## **359 Kent Street, 436 and 444 MacLaren Street, Ottawa**

Planning Rationale Addendum No. 1  
Official Plan and Zoning By-law Amendment  
March 16, 2023

Prepared for 359 Kent Street Ltd.

Figure 3: Viewplane Analysis along Kent Street

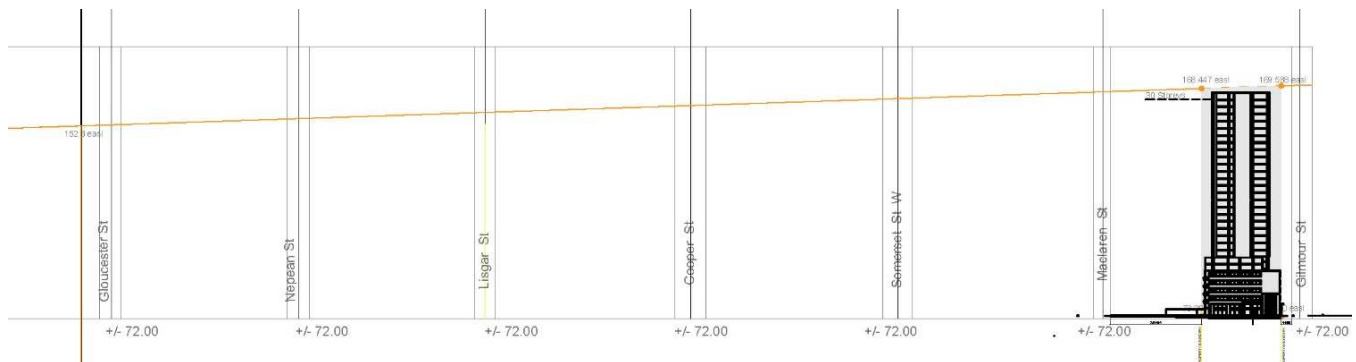
- 2.4.8 Policy 3.9.5.5.11 states that a proposed landmark building shall “fully respect the requirements of the Visual Integrity and Symbolic Primacy of the Parliament Buildings and Other National Symbols guidelines related to building height restrictions”. The submission packages lack information regarding the protection of views of the Parliament Buildings and Other National Symbols. An accurate analysis of views from the various vantage points identified in the Official Plan is required.

**The parliamentary view protections do not directly impact the subject property. The proposed height of 30 storeys has been determined to be below a projection of the angular plane described on Schedule C6B (Figure 3).**

**As discussed within this Addendum, the viewplane for the Parliament Building has been extrapolated south to determine what building height would be permitted without impacting the roofline of Parliament. This has directly led to the proposed height of 30 storeys.**
